VILLAGE *of* NORTHPORT
INCORPORATED IN 1894
224 Main Street, Northport, New York 11768, 631-261-7502, fax: 631-261-7521

Re: Building Permit Application No. 20-101 – First Floor Addition of General Living Space with Adjacent Front and Rear Covered Porch. Second Floor Addition of Three Bedrooms and Bathroom to Residence.
35 Waterside Ave, Northport, N.Y. S:11 B:3 L: 79
Residence District D

INC. VILLAGE OF NORTHPORT
BOARD OF ZONING APPEALS
APPLICATION

EXHIBIT
2

PLOT PLAN

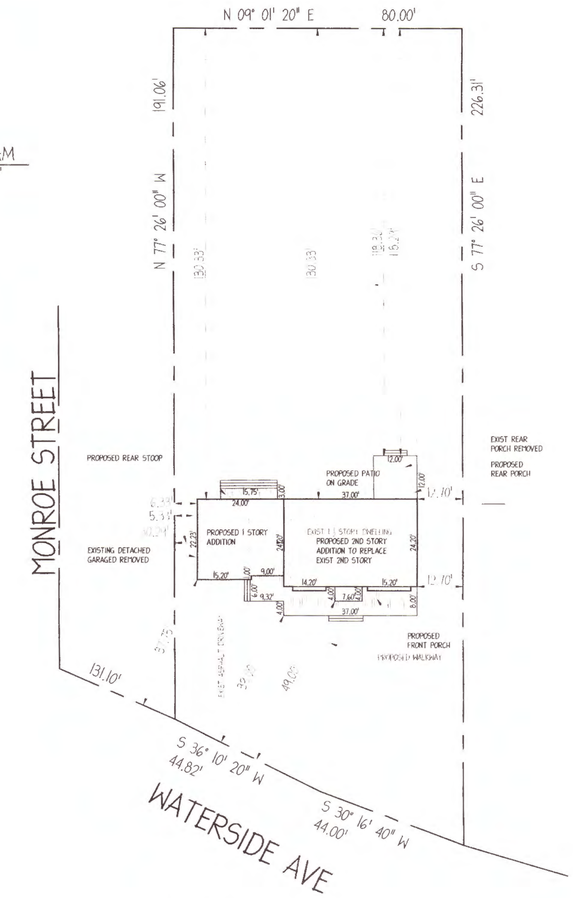
Your application for a building permit to construct additions and alterations at the above-referenced property is hereby denied. Examination of the plot plan by Oyster Bay Drafting and Architecture, P.C. dated 6/23/20 indicates this is a non-conforming lot specific to Side Yard Setback 5.33ft. The proposed construction would create a Side Yard Setback of approximately 6.33ft. and therefore is an addition to a non-conforming structure.

The proposed construction, therefore, would be in violation of the Code of the Village of Northport, Chapter 306, "Zoning," Section 306-22H (4) in the Residence D District.

Section 306-22H (4): Side Yard Setback from 12ft. required to 6.33ft. proposed.
